SERVICE INFORMATION LETTER NO. SIL20A1-010

FAA Airworthiness Directive No 2011-14-09
ATA Code: 74 - Ignition

REPLACEMENT OF WASHER PART NO. 944072 (FLY WHEEL HUB) FOR ROTAX® ENGINE TYPE 912 AND 914 (SERIES)

SB-912-058

Fig. 1

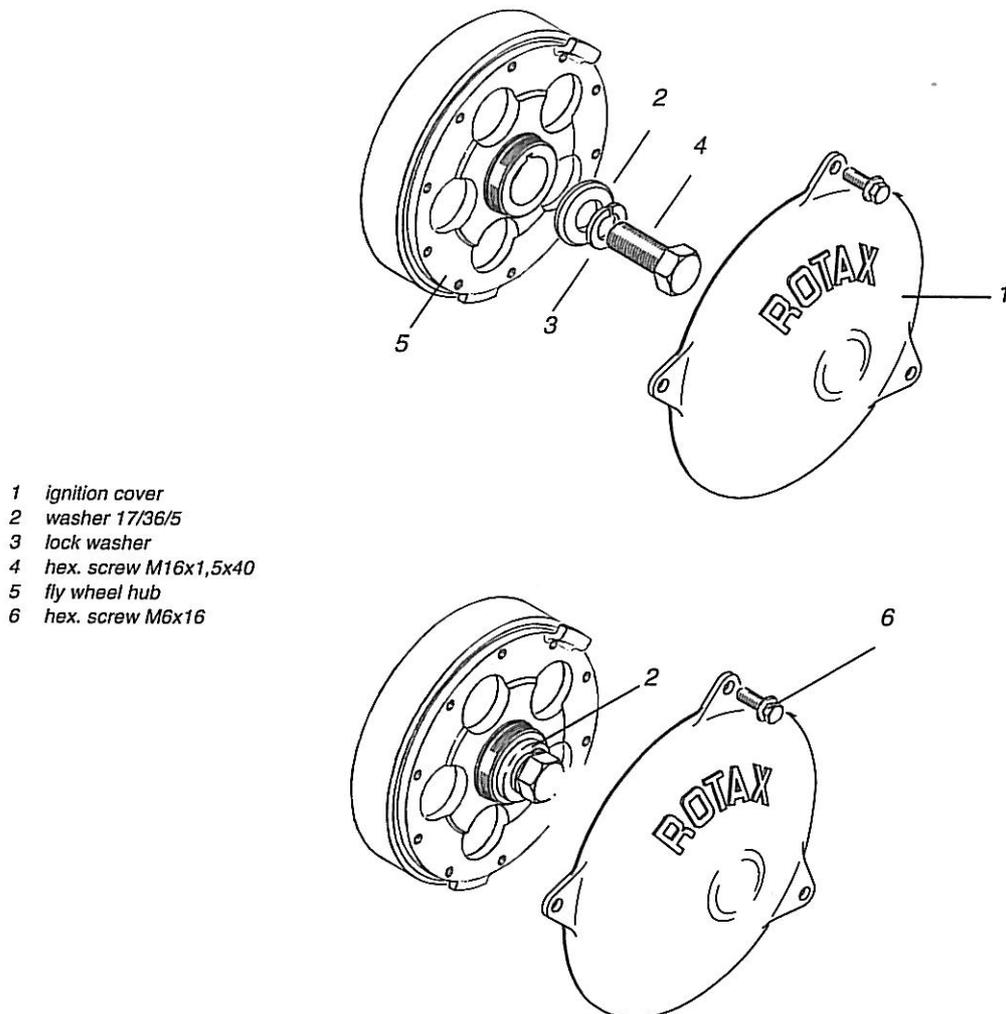
1. Remove ignition cover (1).
2. Lock the crankshaft in accordance with the relevant Maintenance Manual (Line).
3. Remove hex. screw (4) in accordance with the relevant Maintenance Manual (Heavy).

■ CAUTION: If the fly wheel hub has loosened during the disassembly and/or in case of doubt, then remove, clean and install the fly wheel hub in accordance with the relevant Maintenance Manual. In this case the tightening torque is 45 Nm (33.2 ft.lb) + 180° angle to rotation.

4. Install hex. screw (4). **Tightening torque 120 Nm (89 ft.lb).**

■ CAUTION: During installation the new washer (2) part no. 944072 must be used.

5. Remove locking pin of crankshaft in accordance with the relevant Maintenance Manual.
6. Check trigger coil gap, if necessary adjust it in accordance with the relevant Maintenance Manual.
7. Install ignition cover (1). The hex. screws (6) are locked with Loctite 221. Tightening torque 5 Nm (44 in. lb.).
